COMMUNITY DEVELOPMENT DEPARTMENT REPORT

SUBJECT: H-2024-0049
Fairview Drive-Through CUP, MDA

LOCATION: 4300 E. Fairview Avenue, located in a portion of the SW ¼ of the SE ¼, Section 4, T3N, R1E

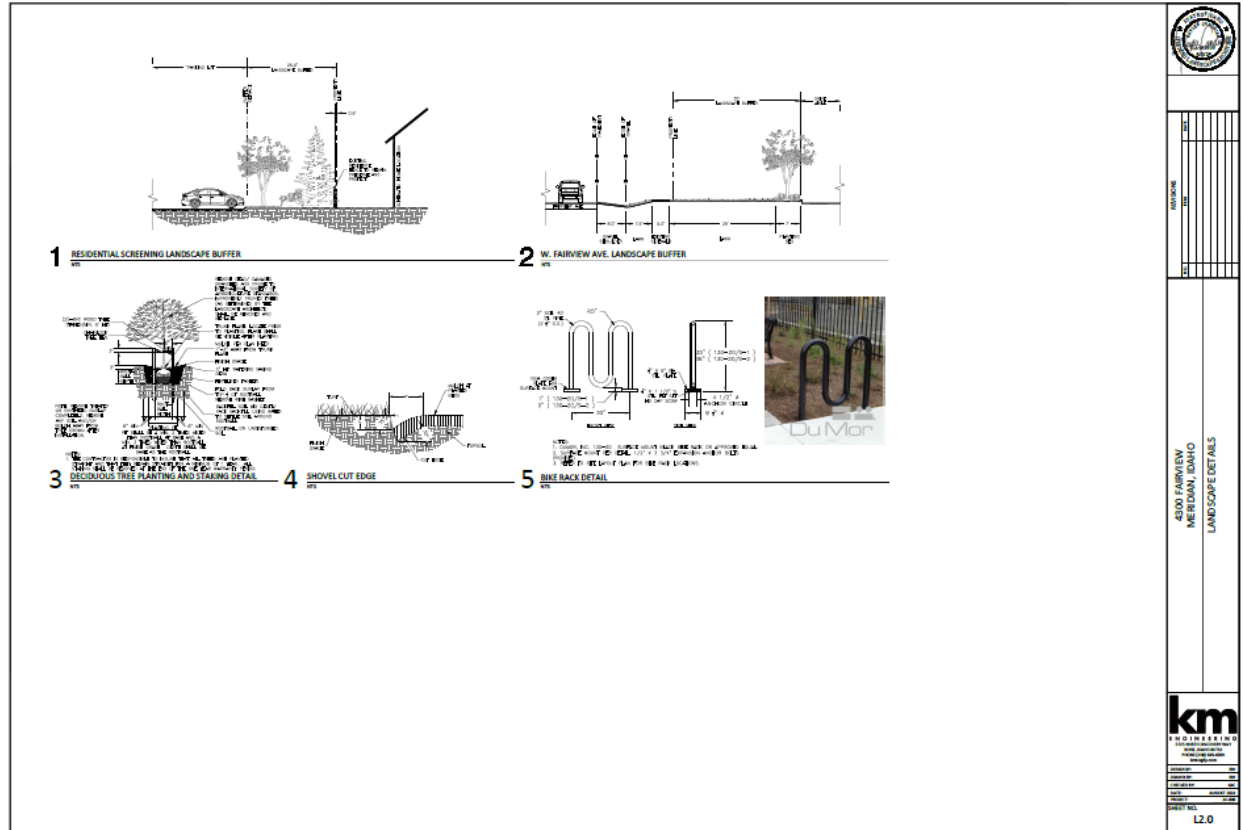
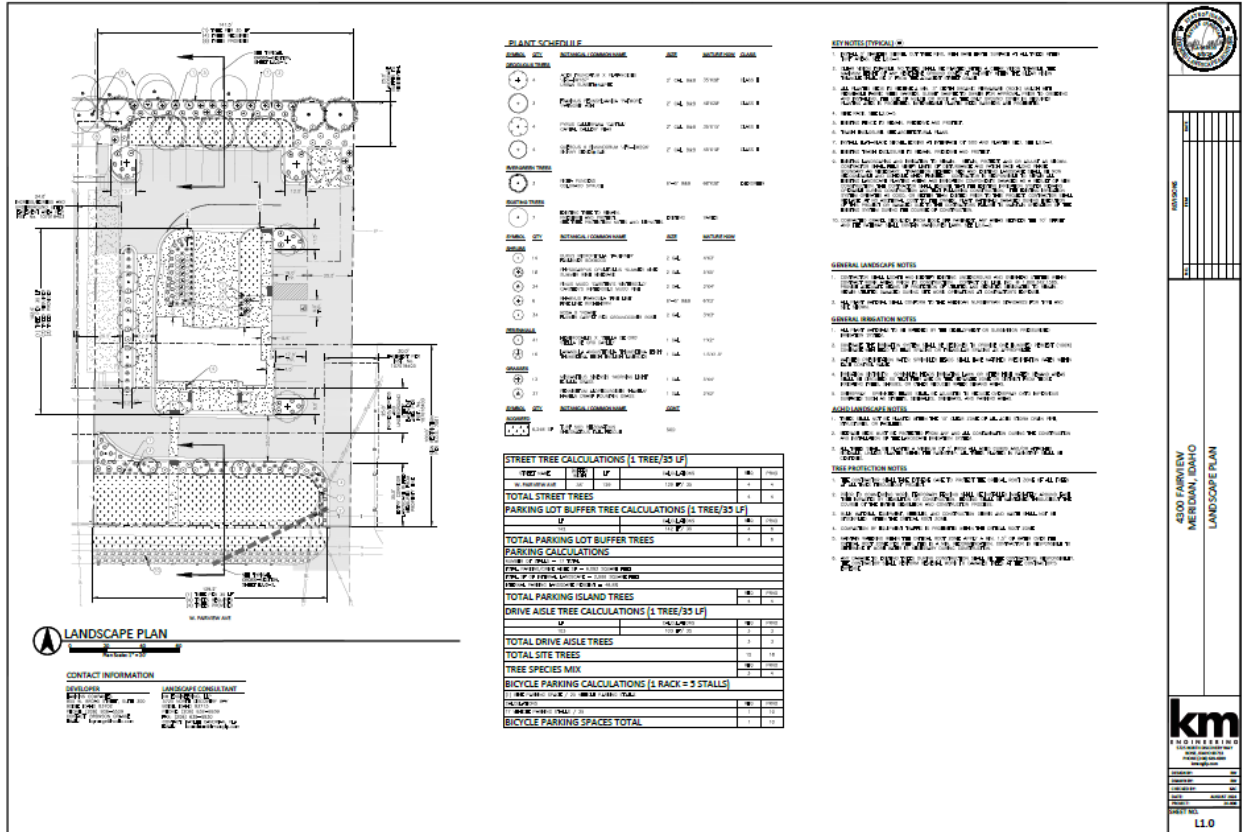
In reviewing the site plan, staff feels moving the employee parking to the south side of the lot to align with the parking layout for the adjacent bank to the west. Staff feels this will help minimize conflicts between vehicles using the coffee shop drive-through and customers accessing the quick-lube oil change facility, while also ensuring sufficient stacking space for the coffee shop drive-through.

In reviewing the site plan layout, staff recommends that employee parking be located on the south side of the lot to align with the parking layout for the adjacent bank to the west. This arrangement would help minimize conflicts between vehicles using the coffee shop drive-through and customers accessing the quick-lube oil change facility, while also ensuring sufficient stacking space for the coffee shop drive-through.

The applicant is requesting a Council waiver to place the trash enclosure into the landscape buffer to match the existing trash enclosure for the adjacent property to the west. Staff is asking the applicant to work with the adjacent property owner to expand the existing trash enclosure and request council waiver to reduce the landscape buffer for the area in which the trash enclosure is located.

Per UDC 11-3C Restaurants require one (1) parking space for every two hundred and fifty (250) square feet of gross floor area. The total number of parking spaces required is seven (7). The applicant is proposing seventeen (17) parking spaces which exceeds the required number parking spaces for this proposal. The applicant will be required to install wheel stops for the compact stalls or widen the sidewalk to seven (7) feet to prevent vehicles from overhanging on the sidewalk.

Fifteen (15) days prior to the City Council hearing, the applicant shall provide the revised concept plan for the site and landscaping plan showing the employee parking located on the south side of the lot to align with the parking layout for the adjacent bank to the west or a layout that is amenable to the staff and the applicant.

E. Landscape Plan (date: 10/29/2024)

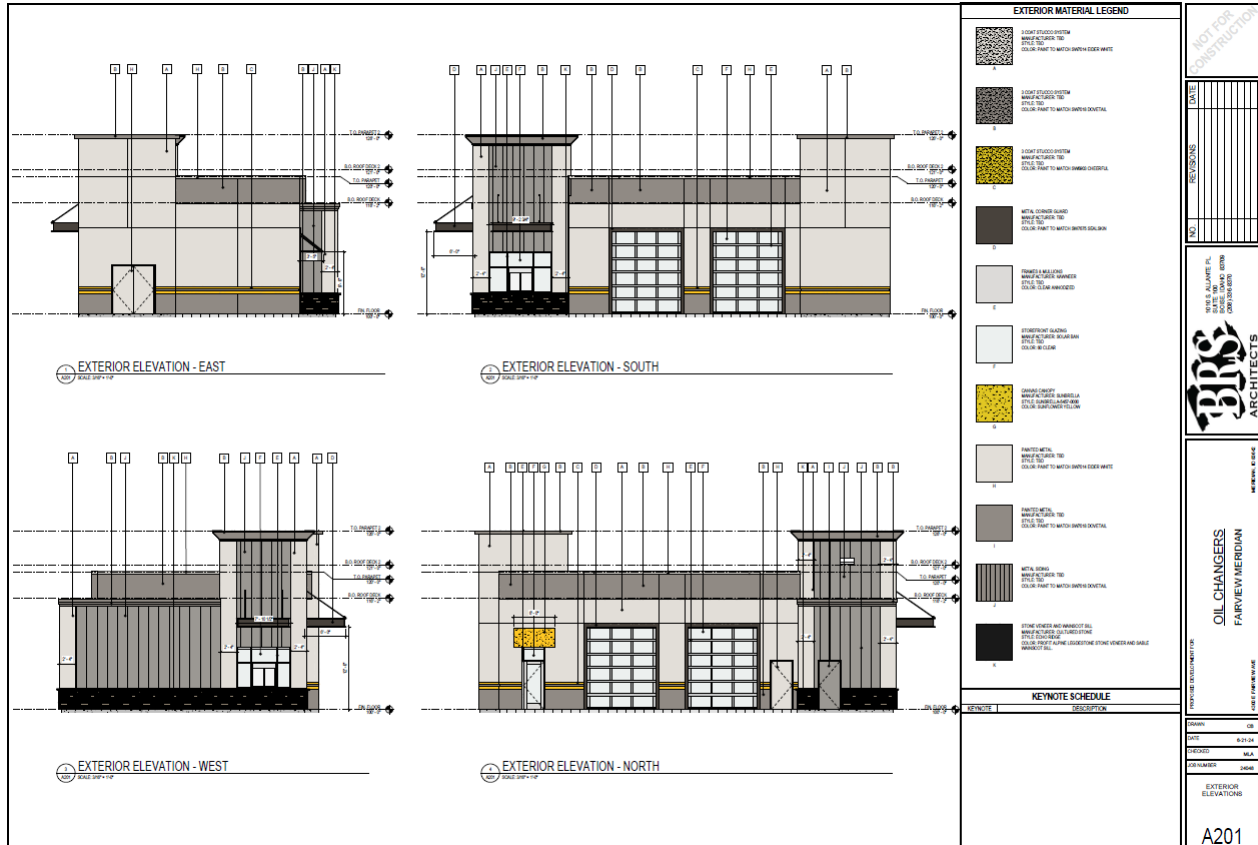
Provide a minimum twenty-five (25) foot wide landscape buffer along the entire north property line, as proposed. Materials used in the buffer shall meet the requirements of UDC 11-3B-9.
